Exit 8 Development

Benchmark Group

CITY OF PORTLAND, MAINE
MEMORANDUM

TO: Chair Carroll and Members of the Planning Board
FROM: Richard Knowland, Senior Planner
DATE: March 10, 1998
SUBJECT: Keenan Auction Property at 191 Riverside Street, Site Plan and Subdivision Review

Site plan D3 and D4 Notations

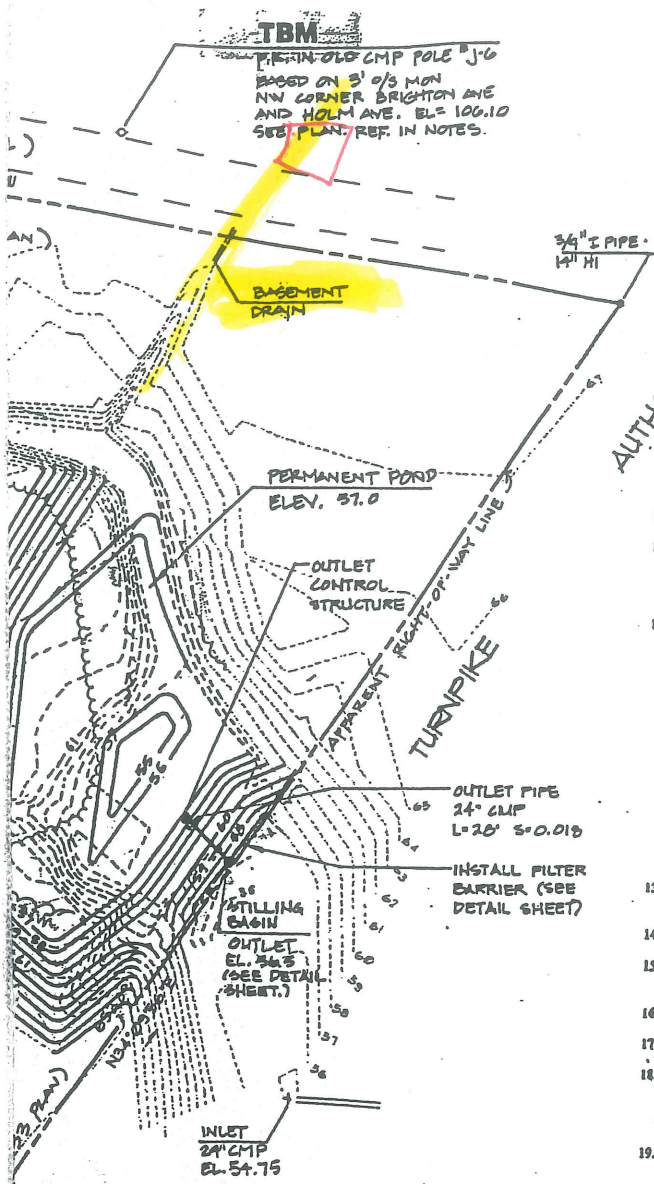
If you would refer to Watershed Map D-3, you will note that no basement drains are shown other than the one at the end of Campbell St. The property at 4 Campbell Rd and 11 Campbell Rd. Have basement drains that drain into this drainage ditch. At the time Mr. Keenan bought and extended the back of the property, the drain at 4 Campbell Rd. was crushed and blocked and nothing was done to correct this situation. On plan "B" the developer is showing a detention pond directly on top of the outlet of the basement drain to the property of 11 Campbell Rd. The drainage ditch also takes care of the storm water from Riverside St down Campbell Rd. to a detention basin at the back of Keenan property. This drainage ditch and basement drains are grandfather under drainage rights. Please refer to General Notes #19C and #20B. on site plan D3, which describe these rights as deeded by the original owner Charles Grant. A copy of this plan is enclosed with highlighted notes. I find it amusing to note that "the existing pond treats the storm water before it leaves the site and enters the CMP turnpike culvert." This detention pond will be only about 30 feet from my driveway. This will be breeding grounds for mosquitoes and other health hazards. Any kind of a detention pond in this corner cannot be allowed. I cannot imagine the DEP would allow such a catch basin so close to a residential area.

CONCEPTUAL SITE PLAN
OF:
PROPOSED RETAIL DEVELOPMENT
RIVERSIDE STREET
PORTLAND, MAINE
FOR:
BENCHMARK GROUP
4053 MAPLE ROAD
AMHERST, NY 14226

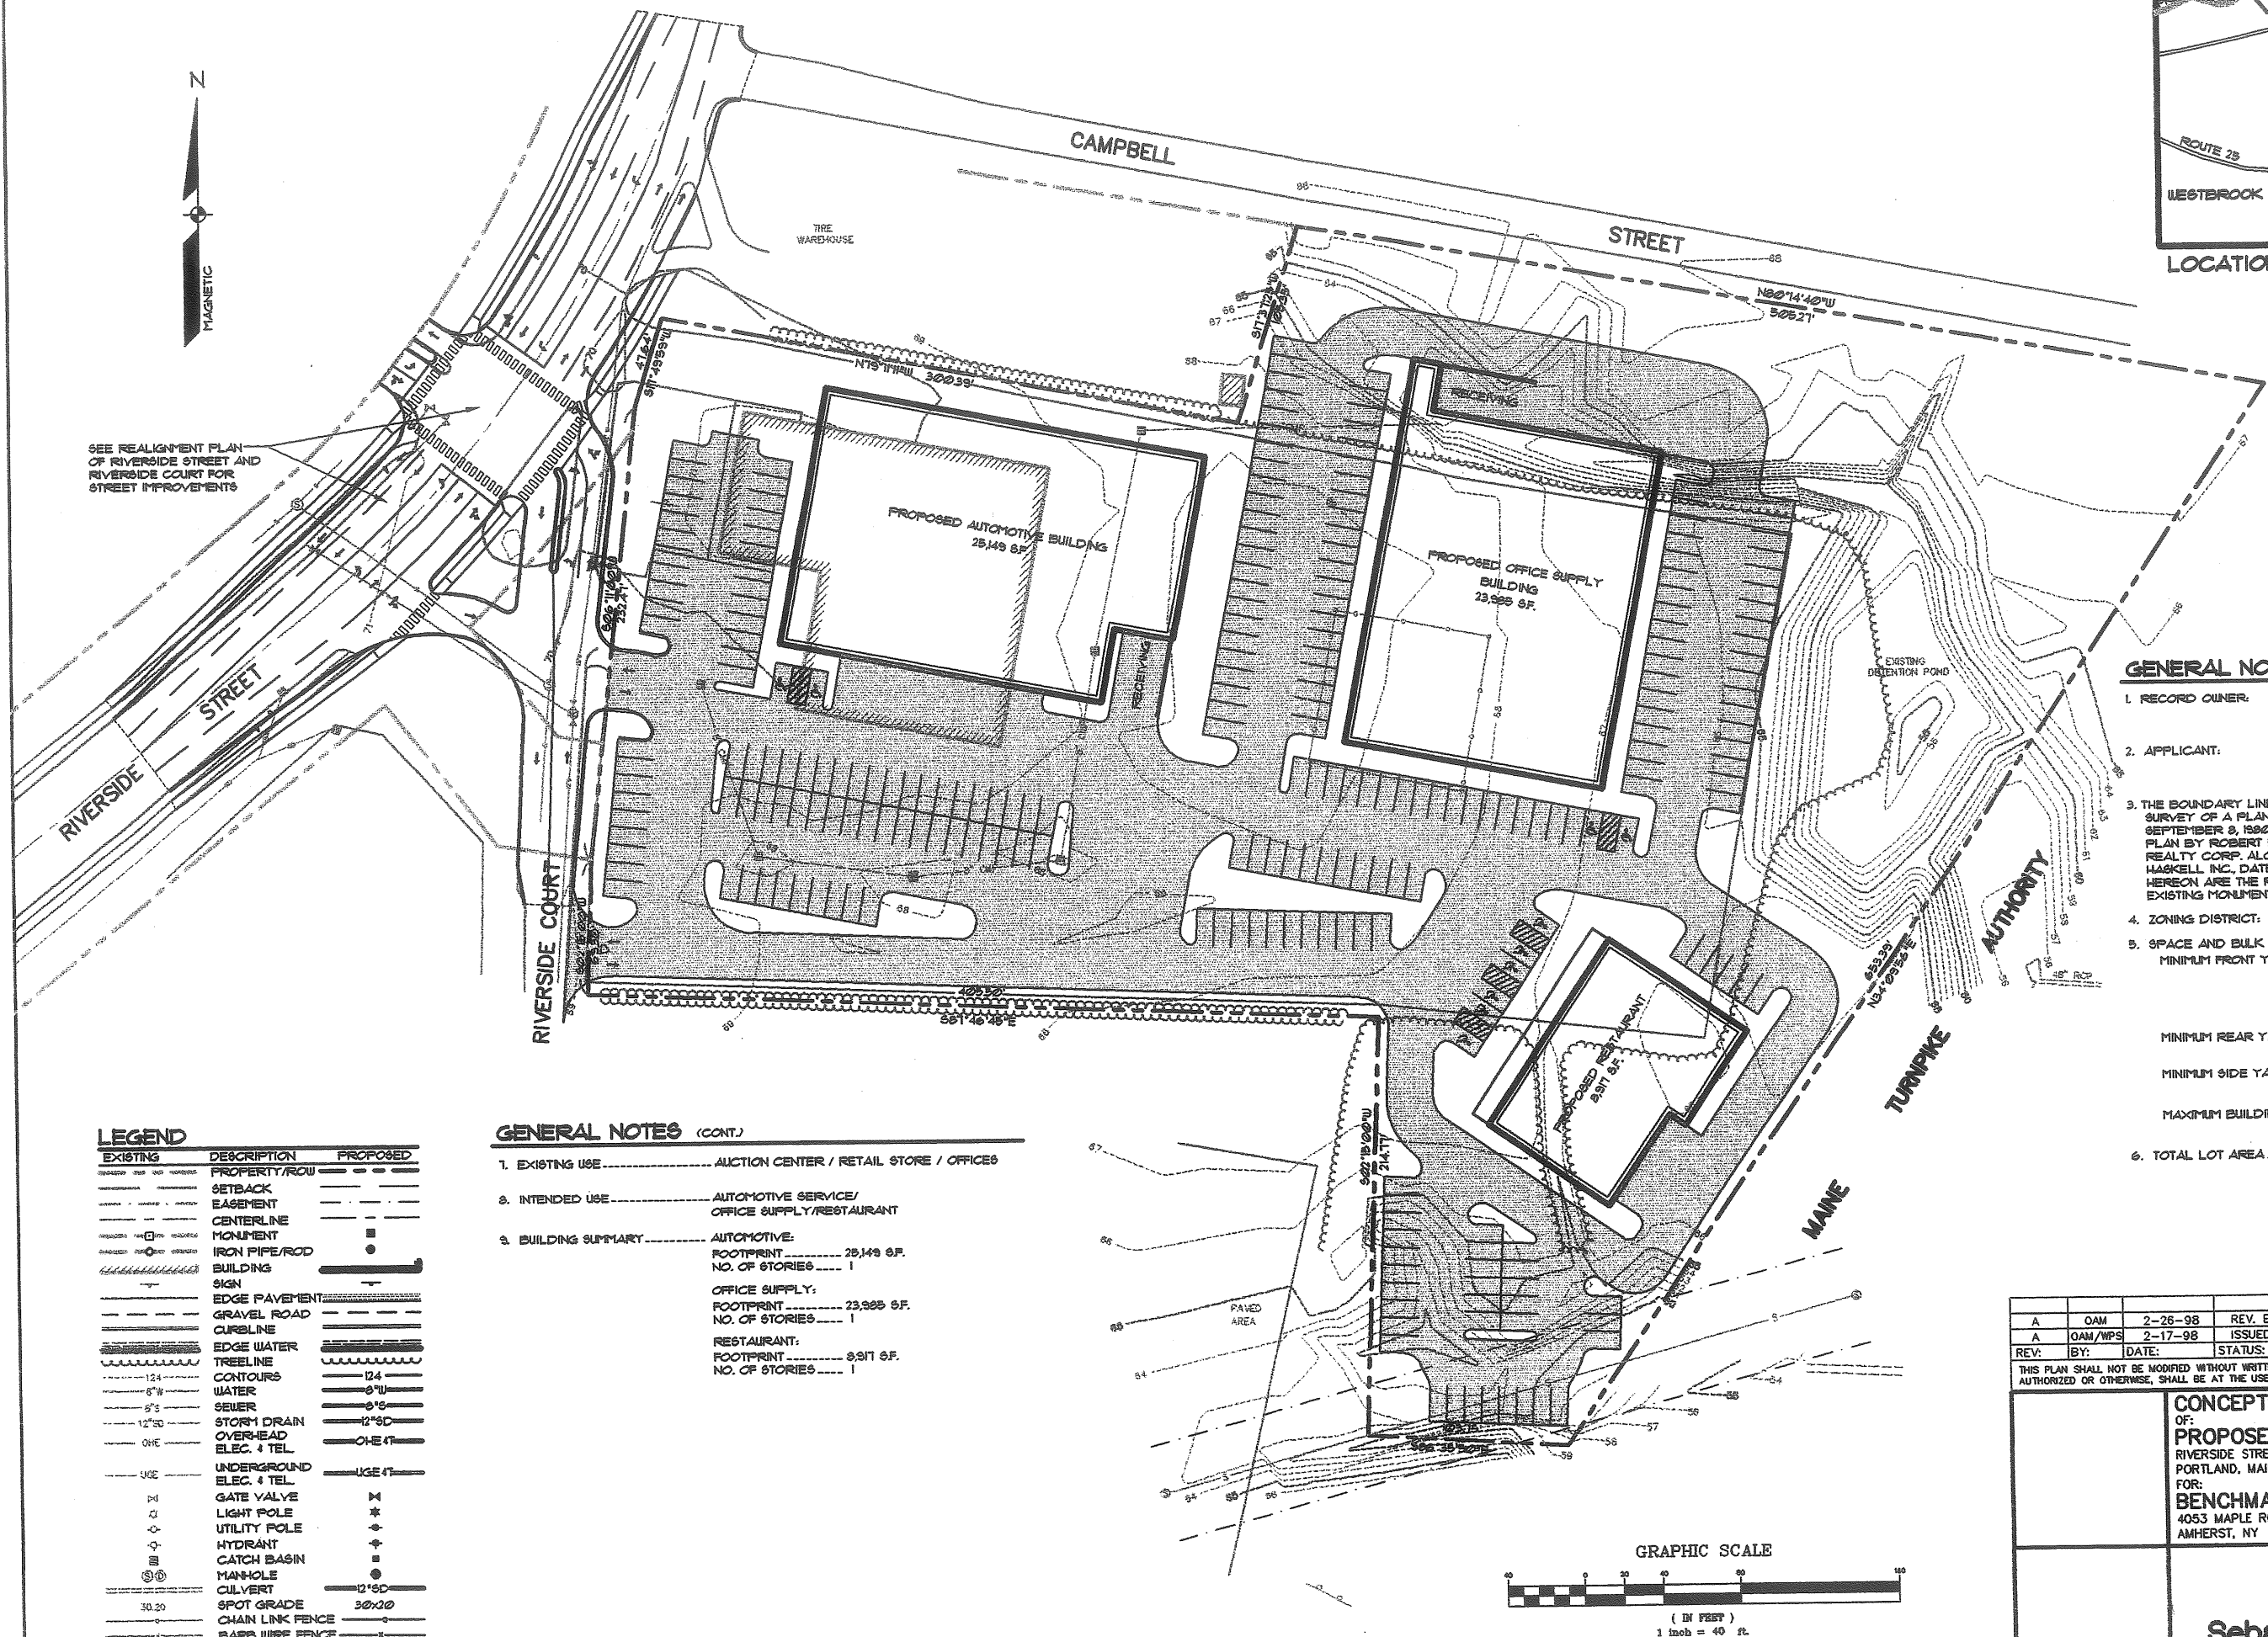
Access is proposed off Riverside Court. The intersection of Riverside Court and Riverside Street is proposed to be reconfigured as shown on the site plan along with a traffic light. City Traffic, ⁶⁻²³⁻⁹⁸ has requested a full traffic report for this project. This analysis would include the area from the Warren Avenue/Riverside Street intersection to the Riverside Street/Brighton Avenue intersection. The Riverside Street area has experienced considerable growth recently (Home Depot, among others). At the writing of this report, a traffic report has not been submitted, although a draft report is expected to be forwarded for this packet (see Attachment D.) Both the project traffic engineer and Larry Ash will be attending Tuesday's workshop.

A sidewalk will need to be constructed along the entire street frontage of the project (Riverside Street and Riverside Court.) Pedestrian circulation needs within the site should be addressed. Staff would suggest a sidewalk along the southerly property line from Riverside Court to the restaurant. Crosswalks should be added between buildings and logical pedestrian circulation and crossing points.

248 parking spaces are proposed. Under sec. 14-526(a)(2), the Board determines the appropriate number of parking spaces for the development since the floor area of buildings exceeds 50,00 sq. ft. The applicant needs to provide documentation on the parking demand for this development.

The applicant indicates that an existing detention pond on the property can be modified to accommodate the stormwater needs of the development. Stormwater calculations need to be submitted. Stormwater from the site flows into a 48-inch pipe under the turnpike that is part of the Capisic Brook watershed.

Given the large size of the parking lot, water quality issues need to be addressed. An existing drainage area on the northerly side of the property (near the office supply building) will be filled.

A landscaping plan needs to be submitted addressing landscaping along the perimeter and within the parking lot. The site plan indicates that the restaurant and related parking lot area requires existing vegetation to be cut. Since the building (40 foot setback) and parking lot (5 foot setback) will be close to the turnpike right-of-way an appropriate landscaping treatment needs to be designed.

The existing parking lot has a number of floodlights mounted on poles. A lighting plan needs to be submitted, indicating the proposed lighting fixtures, pole height and photometrics.
